**Waterloo Catholic
District School Board**

ADDENDUM # 001

**St Peter CES Renovation
92 Avenue Rd, Cambridge, ON N1R 1C1
RFT No. 2026-13**

Issue Date:

5 EXTERIOR DOOR ELEVATIONS
SCALE = 1:50

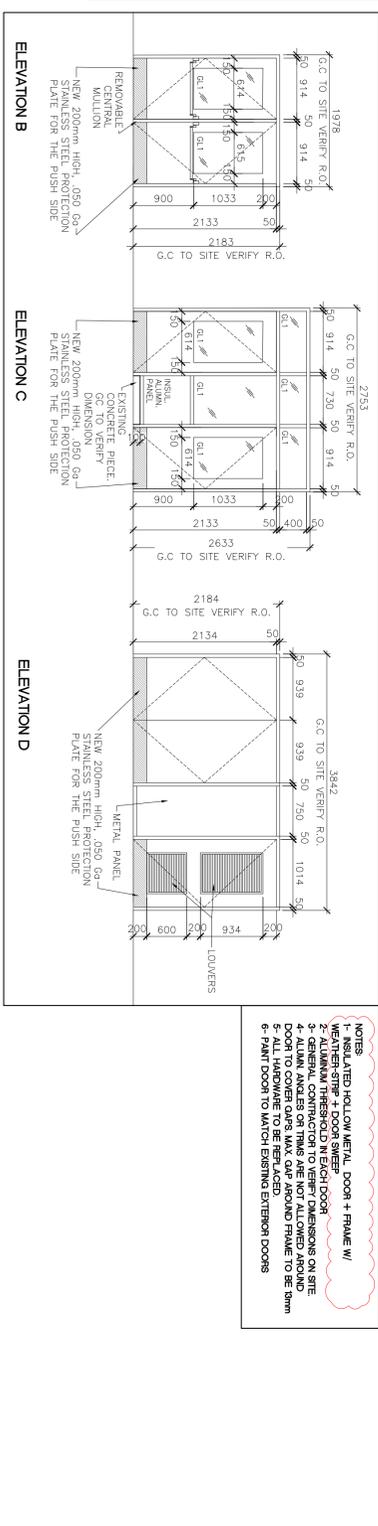
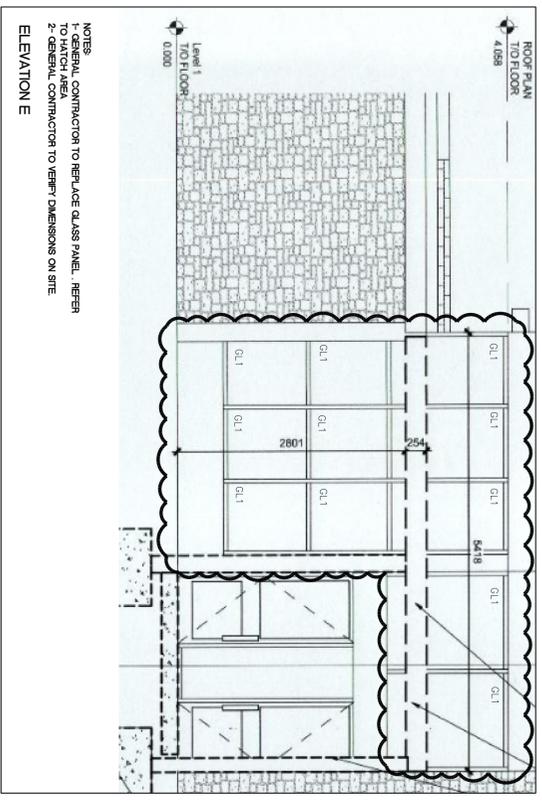
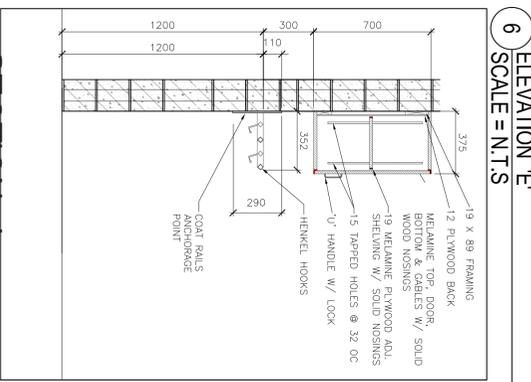
- 1- Reference 5/A101-Notes call for insulated Aluminum Door + Frame. There is no Aluminum spec section. Please confirm if these entrances are to be Aluminum or Steel. If aluminum, is there a spec section to reference.
- 2- A101 Glass type notes contradict 2.1.e Glass Materials and 2.3 Glazing schedule in specs for Both GL-1 & GL-2. Please confirm glass types required.

- 1- Do Exit 4, Exit 7, Exit 8, & Exit 9 on the door schedule A101 require new glass or are these existing
- 2- A101 Elevation E states contractors to replace glass panels. Can we please have dimensions for this glass?
- 3- A101 Glass type schedule states Energy Select Low-e, but spec section 08810 glazing states Solarban 60 as the low-e. Can you please confirm what low-e is required?

- 1- All exterior doors are Hollow Metal
- 2- Glass types as per Specs, See attached revised spec Section 08810 – Glazing, to change GL-2.

- 1- Refer to drawing A101, detail 5: all doors are new.
- 2- Below **APPROXIMATE DIMENSIONS**
 - 6 panels: approx. dimension is 1000mm (w) X 1000mm (h)
 - 3 panels: 600mm (w) X 1000mm (h)
 - 2 panels above door: 1200mm (w) X 1000mm (h)
- 3- Refer to Specs, Section 08810, 2.3.5

7 SECTION 1'
SCALE = 1:20

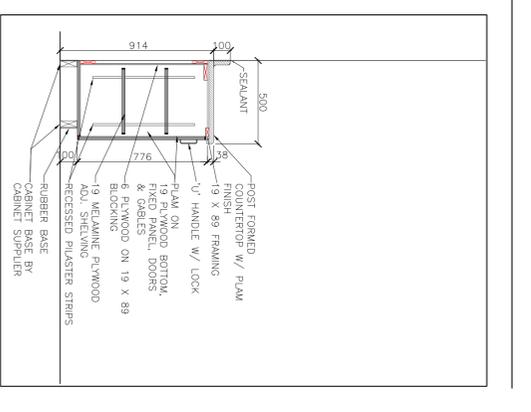
As per Sections 1 and 2 on drawing A101, the top counter is noted to be melamine on the doors, bottom, and gables.

Could you please confirm whether the bottom is to be PLAM or melamine, consistent with the top units?

- 2- Also, please confirm whether 3 mm PVC edge banding is acceptable, or if all exposed edges must be solid wood nosing as indicated in Section 1 (Drawing A101/7).

Melamine

- 1- Refer to answer in Question #9
- 2- 3mm PVC edging is acceptable
- 3- Plastic Laminate on 19mm Particles Board
- 4- No extension are allowed

DRAWING NUMBER
E1 OF 4

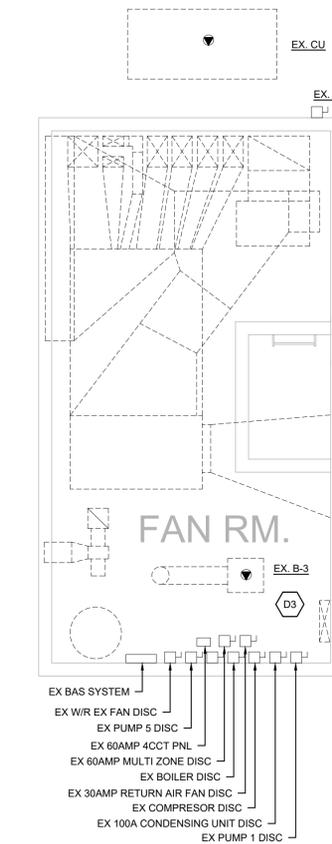
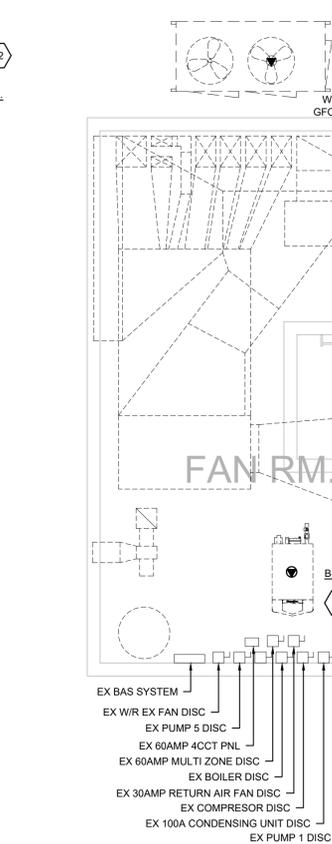
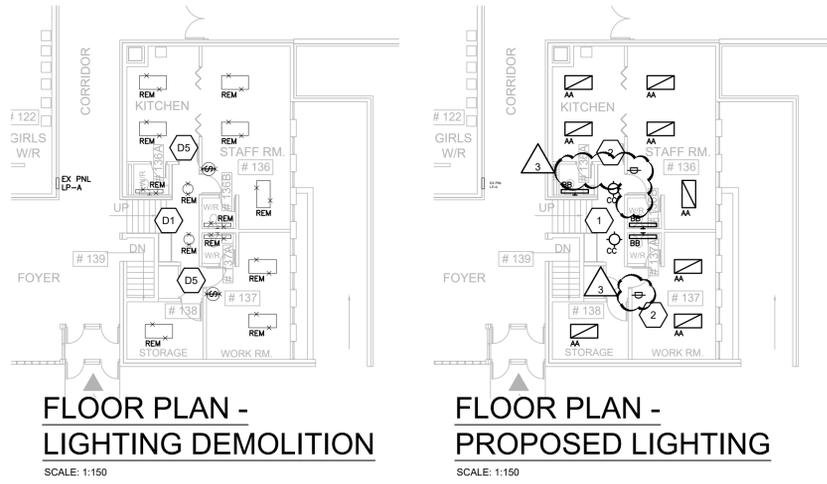
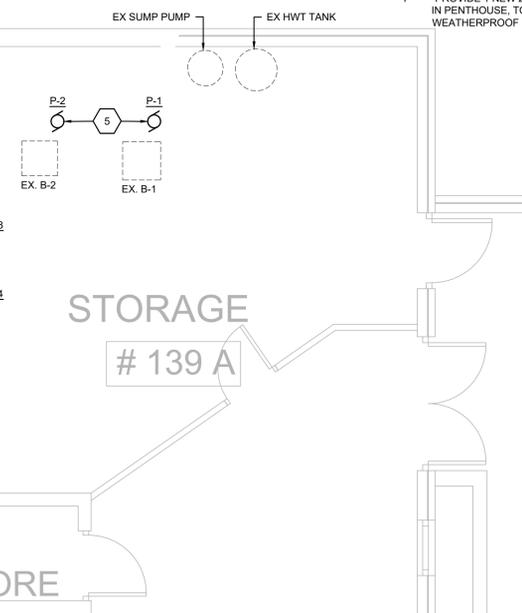
2.1. Reissued Drawing E1:

- 2.1.1. Delete 4, occupancy sensor dimming switches. Washrooms 136A 137A Staff room 136 and Work room 137, existing controls to remain.
- 2.1.2. Provide 2, on/off, dimming switches as indicated on the plan.
- 2.1.3. Revise lighting fixture schedule, type AA: Add passive infrared occupancy detection to fixture description to be built into the fixture and change lens type.
